Midway City Council
18 July 2023
Regular Meeting

Malinka Subdivision /
Amended Final Approval

CITY COUNCIL MEETING STAFF REPORT

DATE OF MEETING: June 6, 2023
NAME OF PROJECT: Malinka Density Reduction Subdivision
NAME OF APPLICANT: Berg Engineering
PROPERTY OWNER: Peter and Emily Malinka
AGENDA ITEM: Revised Preliminary/Final Approval
LOCATION OF ITEM: 150 North 100 East
ZONING DESIGNATION: R-1-15

PETER MALINKA
MALINKA SUBDIVISION
SITE PLAN

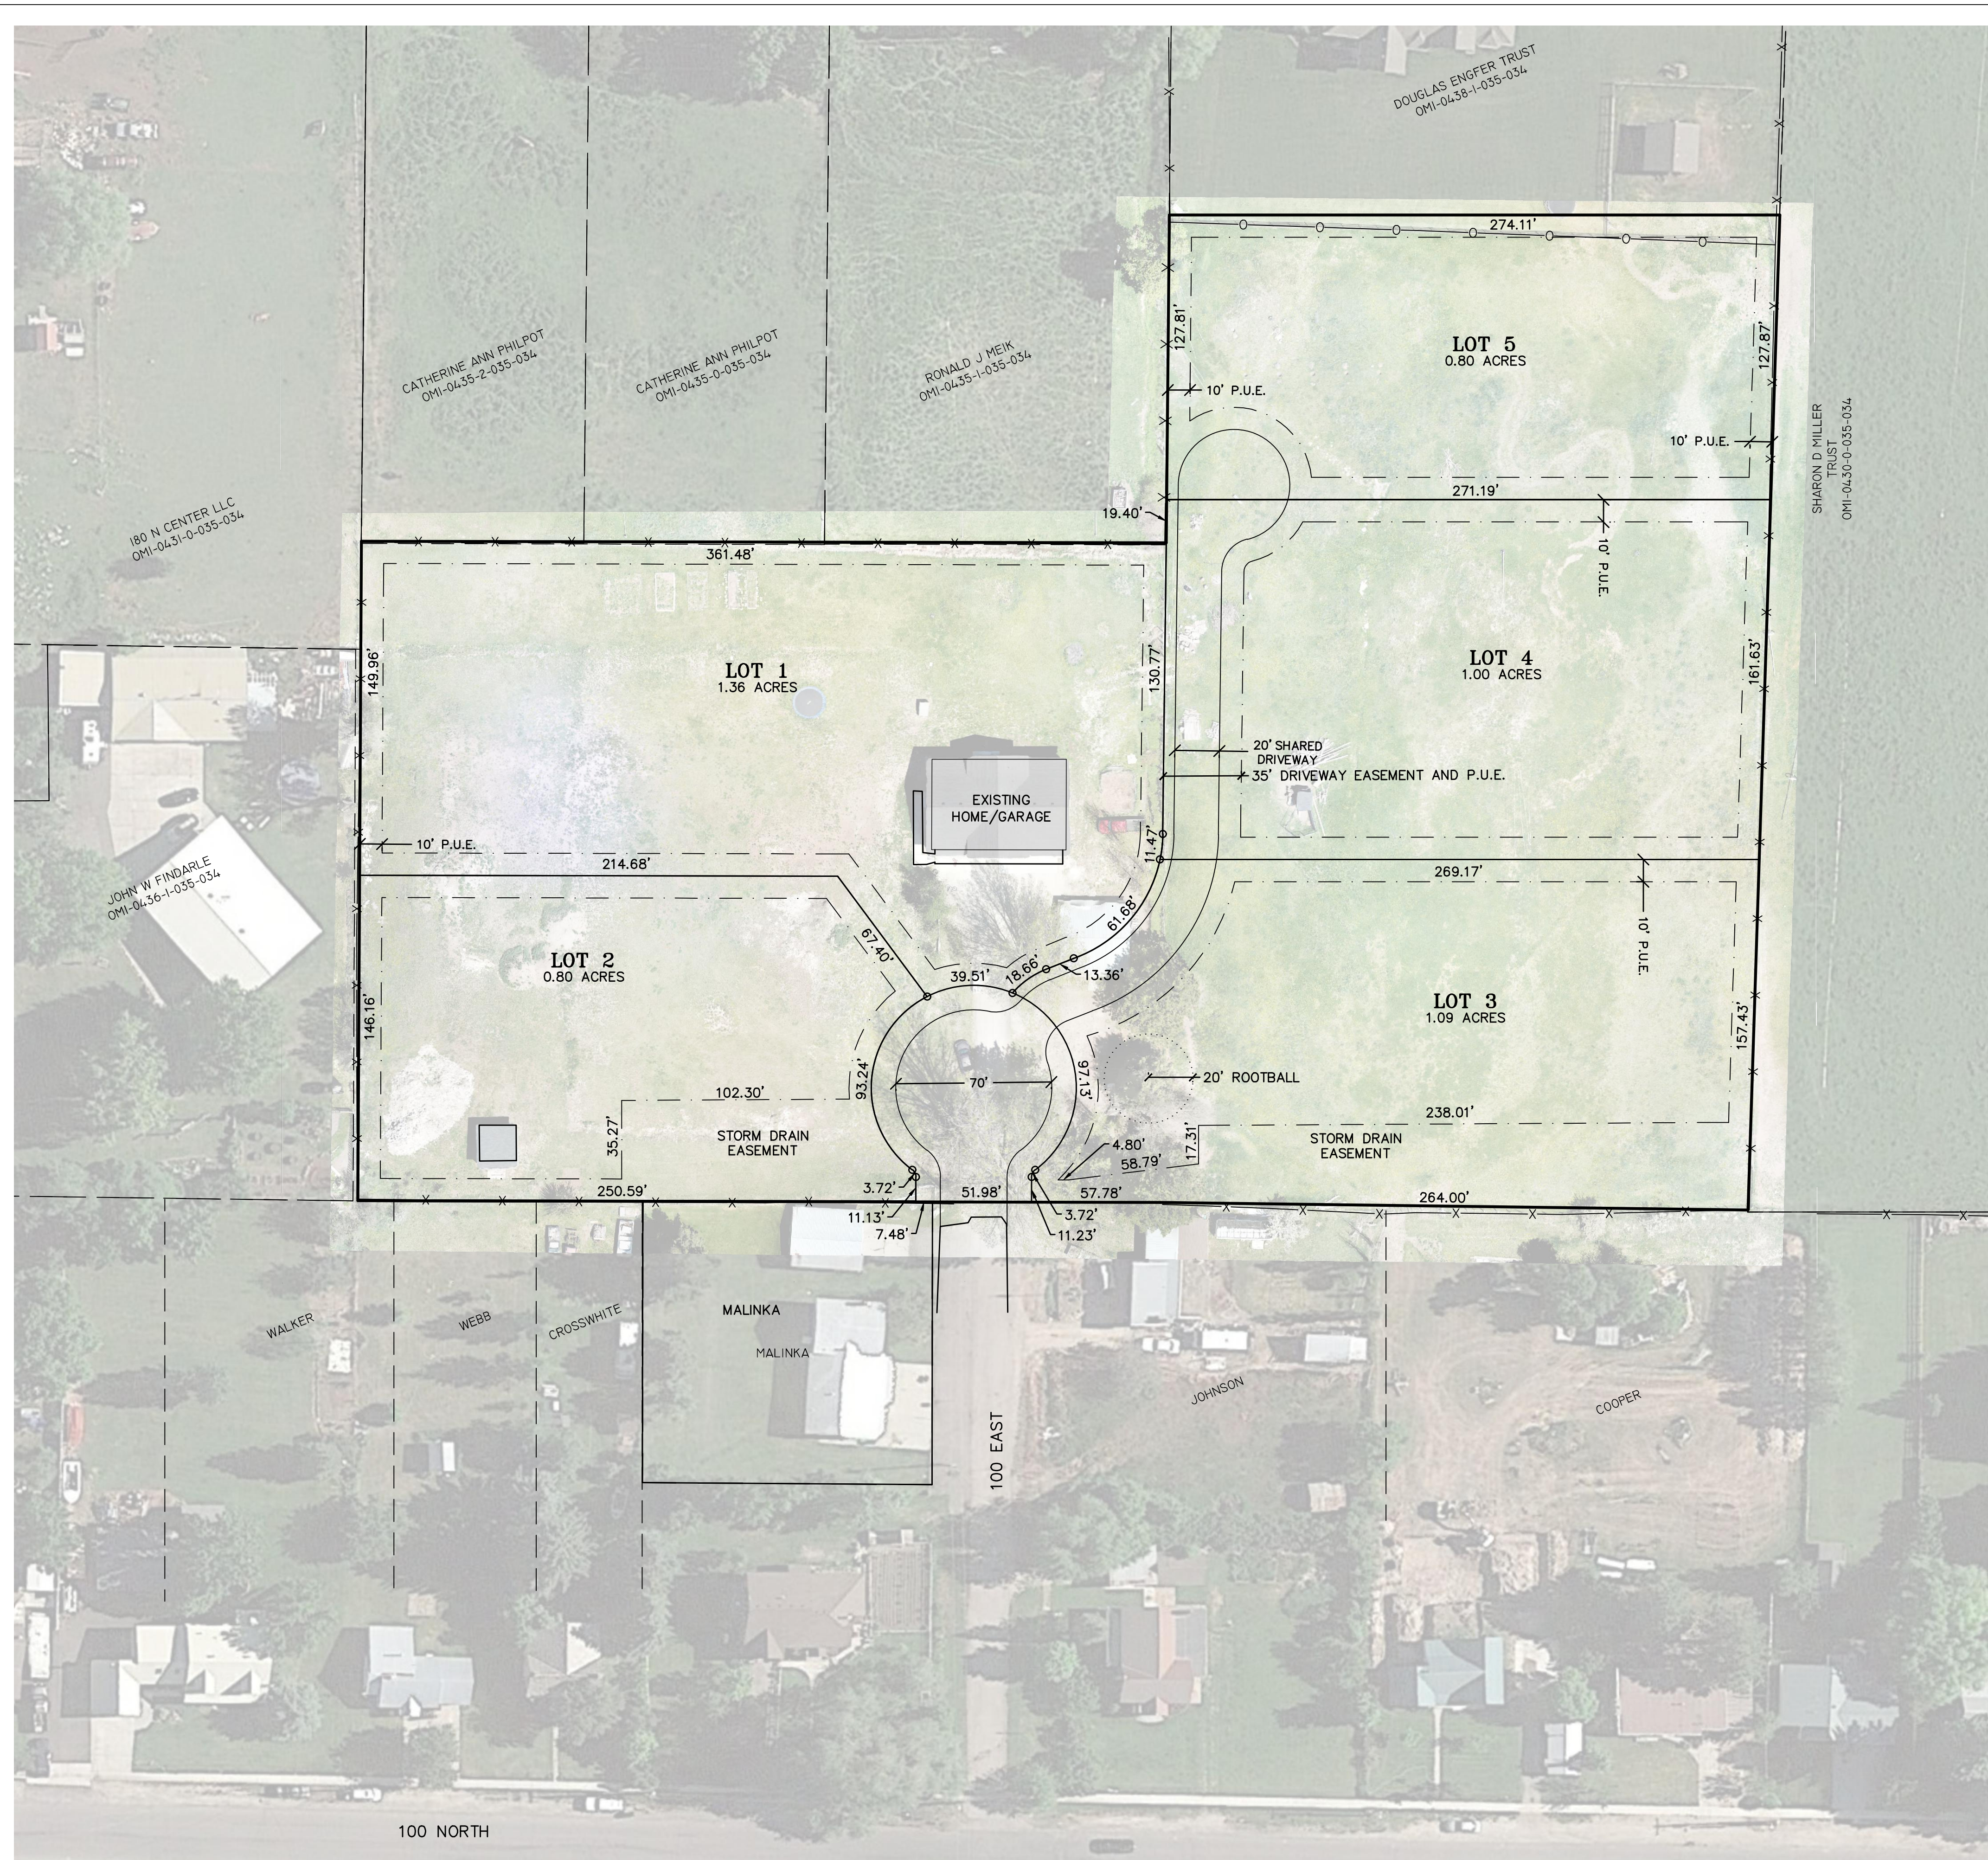
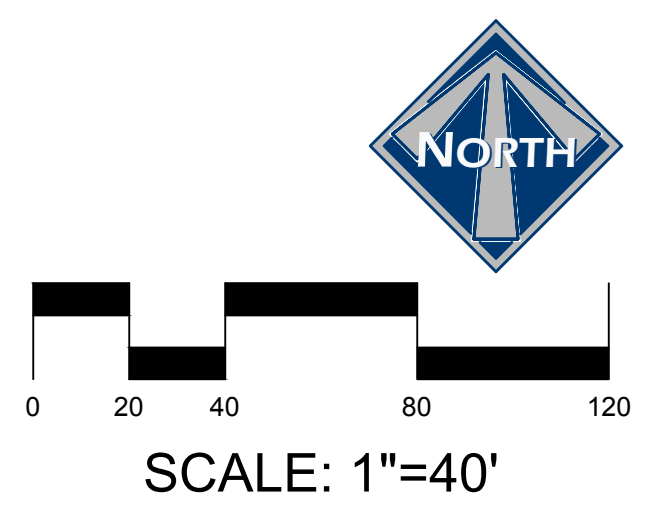
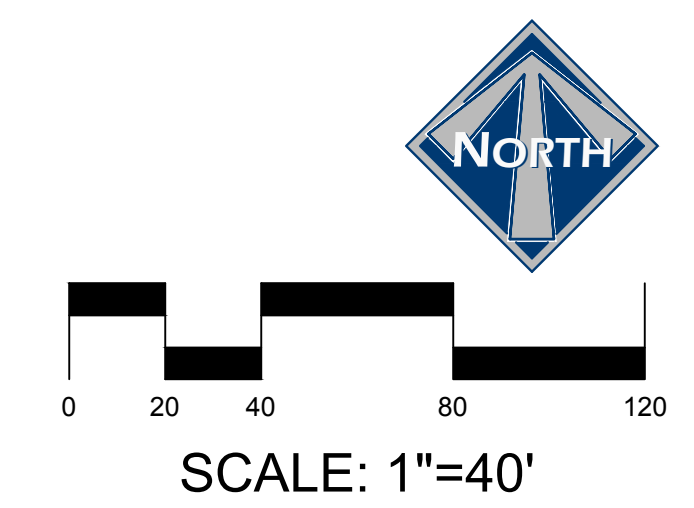
The motion specifically stated that the diameter of the cul-de-sac could be reduced from 90' to 80' and be more symmetrical. Since the motion was made, an arborist has visited the site and arrived at the conclusion that more space is needed to save the tree. Paul Berg has designed a cul-de-sac that is more symmetrical (see attached) but to have the space needed to save the tree, the diameter of the cul-de-sac would be limited to 70'. The applicant is petitioning the City Council to revise preliminary/final approval to allow for a 70' diameter cul-de-sac.

In addition to the 20' TPZ, we need a 10' easement along the side of the cul de sac to run the utilities to the lots. To make room for this additional 10 feet, we agreed to move the cul de sac west by roughly 15 feet on the plans. Doing so makes it 100% symmetrical, which meets the requirement for contingency item #2 above.

Taking all of this into account, I asked Paul to prepare a Final Site Plan (see attached). It illustrates the 20' root ball/TPZ and the 10' utility easement and shows the cul de sac's change in location.

Midway Fire Marshall, Tex Couch, reviewed the proposed plans with the 70' diameter cul-de-sac and agrees that the proposal will meet fire code requirements. Midway Engineer, Wes Johnson reviewed the proposed plans with the 70' diameter cul-de-sac and agrees that the proposal will meet engineering requirements for a low traffic count cul-de-sac.

FIGURE D103.1
DEAD-END FIRE APPARATUS ACCESS ROAD TURNAROUND

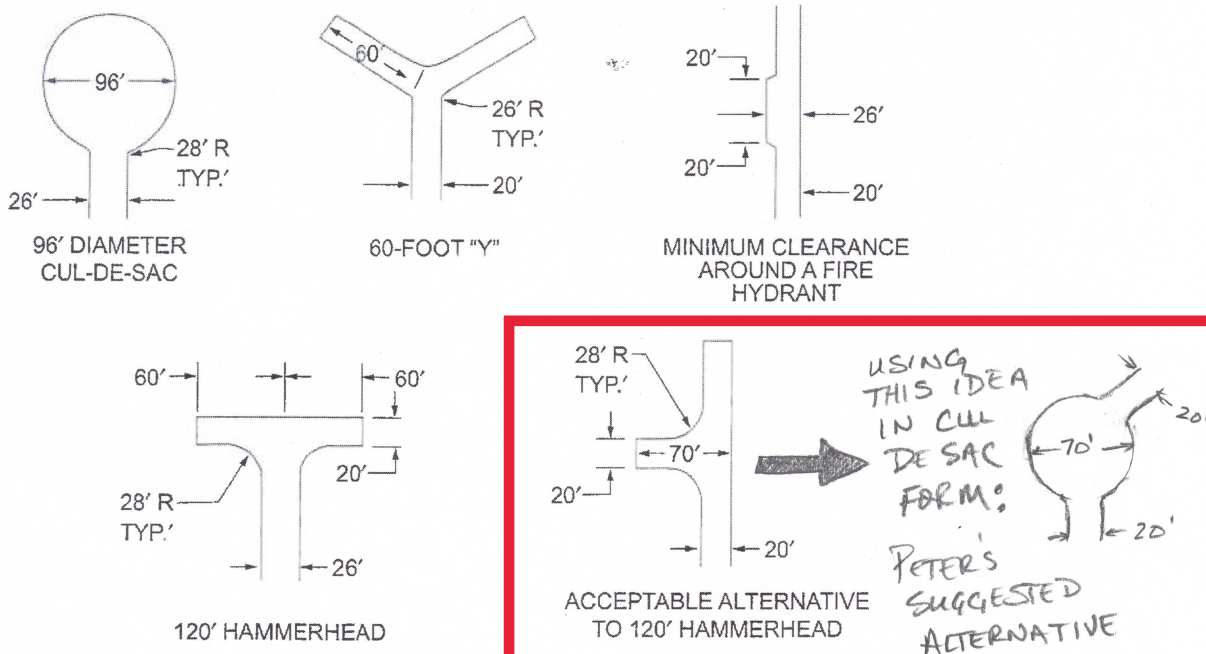
Lastly, see the attached sketch from Appendix D of the international fire code. The sketch uses the last alternative turnaround as a example for appropriate distances, but adds the cul de sac configuration to make it conform to a typical neighborhood.
